# Access Compliance Report

## Public Rights-of-Way

### (Curb Ramps)

Intersection ID: N/A	Main Street: GLEN_LAKE_DR	Cross Street: CASCADE_POINTE_BV	Location: SE
ADA ID: 5CEC934878CA	Ramp Type: MedianPerp	Initial Pass/Fail: Pass	Overall Compliance: No
Codes/Mitigation Info/Possible Solution		Field Measurements/Component Compliance	
Severity Score: 10

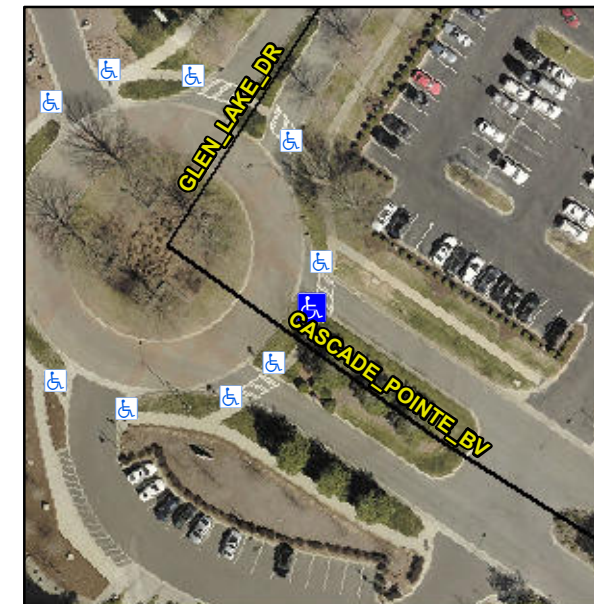
**Not Found, R304.2.2-Perp, R304.3.2-  
Para, R305, R304.5.3**

Compliance	Description	Data	Compliance	Description	Data
N/A	Ramp Length (in)	263.0	Yes	Ramp Slope (%)	6.8
Yes	Ramp Width (in)	59.0	Yes	Ramp XSlope (%)	2.0
N/A	Flare Type LT	None	N/A	Flare Type RT	N/A
N/A	Flare Slope LT (%)	N/A	N/A	Flare Slope RT (%)	N/A
N/A	Flare Traversable LT?	N/A	N/A	Flare Traversable RT?	N/A
Yes	Landing Length (in)	80.0	No	DWS Provided?	No
Yes	Landing Width (in)	60.0	N/A	DWS Contrast?	No
No	Landing Slope (%)	2.8	N/A	DWS Length (in)	N/A
Yes	Landing X Slope (%)	1.2	N/A	DWS Full Width?	No
N/A	Landing Curb? (Y/N)	N/A	N/A	DWS Offset (in)	N/A
N/A	Shared Landing?	No			
Yes	Gutter Ponding?	No	Yes	Gutter Slope (%)	3.4
Yes	Gutter Lip Ht (in)	0.0	No	Gutter X Slope (%)	2.6
N/A	Painted X Walk1?	Yes	N/A	Painted X Walk2?	N/A
	X Walk 1 Direction	To NE		X Walk 2 Direction	N/A
N/A	X Walk 1 Width (in)	93.0	N/A	X Walk 2 Width (in)	N/A
	X Walk 1 Slope (%)	4.6		X Walk 2 Slope (%)	N/A
	X Walk 1 X Slope (%)	0.8		X Walk 2 X Slope (%)	N/A

**Remove & Replace Entire Ramp.  
Remove & Replace Gutter.**
